**AHRI Comments  
on  
Proposed Changes  
CEC Title 24  
Residential Zoned AC**

**California Statewide Utility Codes and Standards Program  
04/12/2011 1 Residential Zoned AC Stakeholder Meeting #2  
Bruce Wilcox April 12, 2011**

**AHRI Version 1.00**

**June 6, 2011**

Figure 1

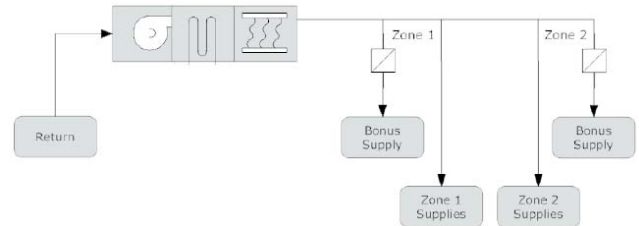
*The slide says that 1/3 of the air will flow to the zone that does not need the air (three ducts open, one duct closed, each duct at 1/3 of the blower Cfm).*

*How is this going to happen? What are the duct sizing rules (for a particular blower table and set of pressure-dissipating devices, for a particular duct run geometry, and for a particular set of duct fittings); and/or what are the air balancing rules (the slide does not show hand dampers)?*

*If a zone thermostat is satisfied, and if 1/3 of the air continues to flow to this zone, how long will it take for zone temperature to drop to an unacceptable level; and how does this transient compare to the time it will take to satisfy the calling zone thermostat?*

*Air outlet performance (throw and noise) depends on make, model and size. Some guidance is needed here.*

*In general, how can practitioners be sure that the proposed (Figure 1) design will always deliver adequate performance for any operating condition?*

### **6.6 Duct Efficiency Comment**

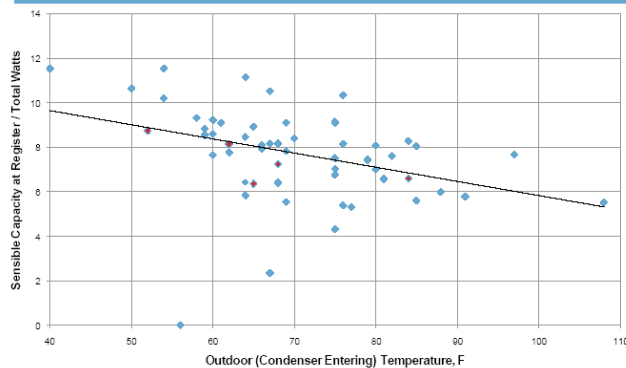
Not sure what MF duct leakage means and what SF means, but the industry knows that duct system efficiency has a significant affect on comfort, equipment performance, energy use, and operating cost.

- n Ducts should be in the conditioned space to the extent possible (considering technical and economic issues).
- n Ducts in an unconditioned space must be sealed to the appropriate standard, and insulated to at least R-6, and preferably to R-8. A vapor retarding jacket may be required for humid climates.
- n Every effort should be made to minimize the surface area of duct runs in an unconditioned space.
- n *Manual J* (MJ8) procedures reward efficient duct systems, and severely penalize inefficient duct systems.

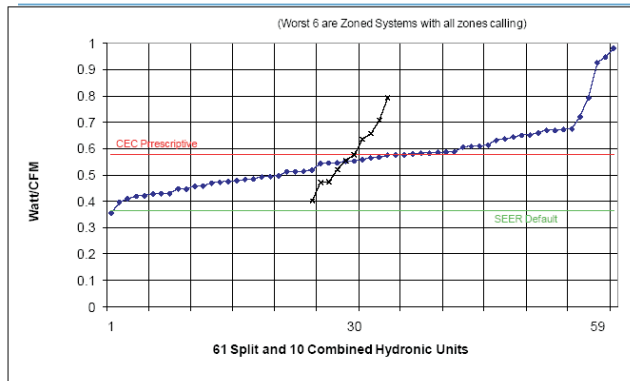
These tests may not be sensitive to equipment installation issues. Was the central equipment correctly sized or oversized? Was Cfm per nominal AHRI ton equivalent for one zone and multizone tests? Is refrigerant charge correct for one zone and multizone tests?

These tests do not seem to be apples-to-apples, as far as the issues that affect momentary system efficiency are concerned. And, the presentation implies that momentary efficiency is equivalent to seasonal efficiency.

This testing effort is affected by too many variables to pass judgement on air zoning. If all the marks on the graph were the same color, which ones should we be most concerned about, and why?

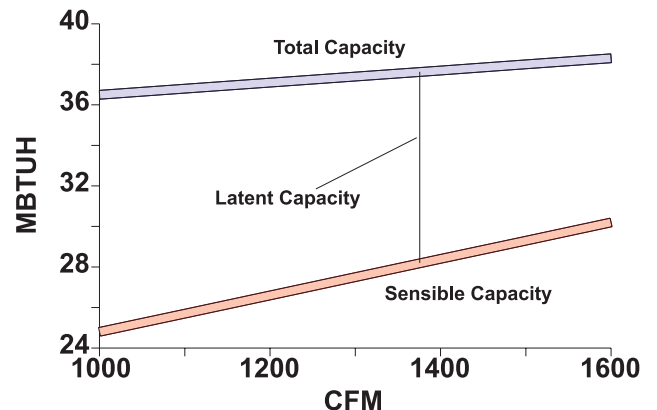
*There may be equipment that cannot operate at 350 Cfm/Ton.*

*Low Cfm per Ton translate s to a smaller value for maximum bypass air (explained later).*

## Slide 17

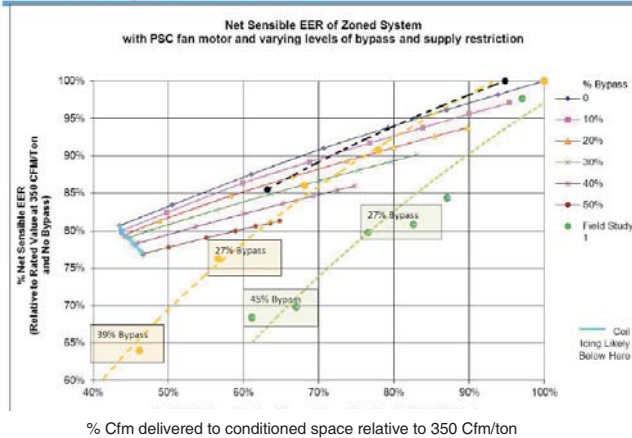
The model and the tests are not compatible. Which one is correct?

With no explanation for what slides 15 and 16 actually mean, it is not possible to comment on slide 17.

If this slide is consistent with Slide 8 (Sensible Capacity at the Register), EER is defined as supply air Btuh divided by system KW. **See Section 8.1 for comments on this practice.**

## Slide 18

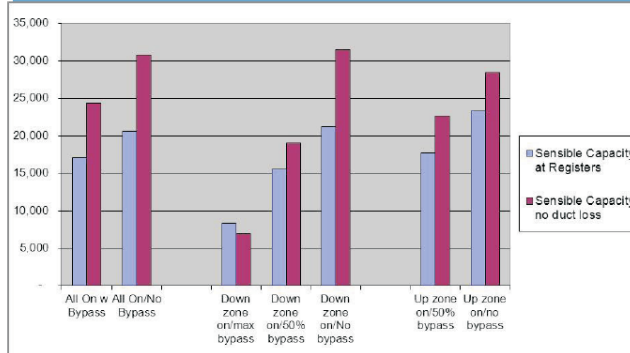
- n How is efficiency defined.  
*Seasonal or momentary?*  
*At unit = Total Btuh out / KW in?*  
*At registers = Sensible Btuh out / KW to unit?*
- n What does "To 14 SEER" mean? Is this the base case (single zone unit)?
- n Wouldn't eliminating zones automatically eliminate Bypass?
- n Do not know enough about the graph to comment.

## Slide 19

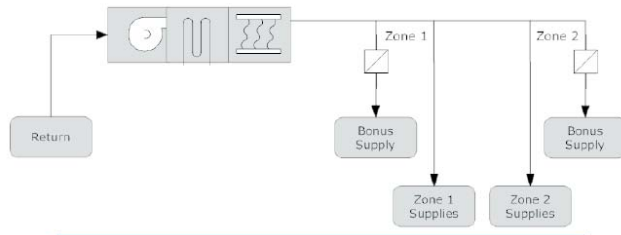
No explanation for the slide, so it is not possible to comment on the slide. However; this is the first slide that says something about duct loss, so the complexity of the issues (and the explanation) are significantly increased.
